T10/07-483r0

To
INCITS T10 Committee

From
Michael Banther, HP

Subject
ADT-2 Signal connection changes

Figure 1

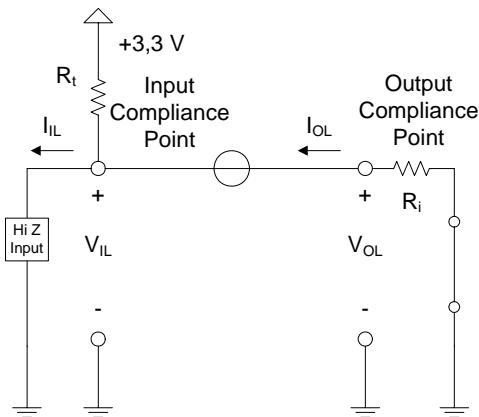
A review of the ADT-2 draft standard specification for the asserted state of a signal connection has revealed that the magnitude of the present current limit may require the use of an external transistor at the input compliance point in order to sink the available charge within the specified fall time. This document proposes a reduced limit for a signal connection in the asserted state to reduce the likelihood of needing an external transistor at the input compliance point.

To aid in discussion, Figure 1 depicts a signal connection in the asserted state and Figure 2 depicts a signal connection in the negated state.

Signal State	Current	Voltage
Asserted	+2 -3 mA < I _{OL}	-0,2 V < V _{OL} < 0,4 V; V _{OL} < 0,2 V _{dd} ^a
Negated	I _{OH} < 50 μA	V _{OH} <= 3,6 V
^a V _{dd} is the positive supply voltage at the receiving end.

Signal State	Current	Voltage
Asserted	+2 -3 mA < I _{IL} at 0 V	-0,2 V < V _{IL} < 0,3 V _{dd} ^a
Negated	I _{OH} < 50 μA at 3,3 V	0,7 V _{dd} ^a < V _{IH} <= 3,6 V; 400 mV < V _{hysteresis}
^a V _{dd} is the positive supply voltage at the receiving end.

Figure 2

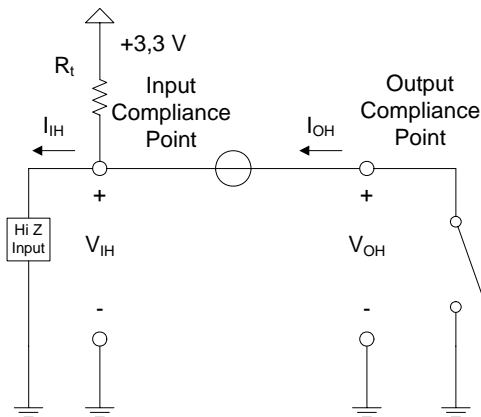
The present ADT-2 draft standard does not specify a limit for the current of a signal connection in the negated state. Neither does it specify the resistance of the terminator. Consequently the standard does not include enough information to ensure interoperability of the signal connections. This document proposes a current limit for a signal connection in the negated state.
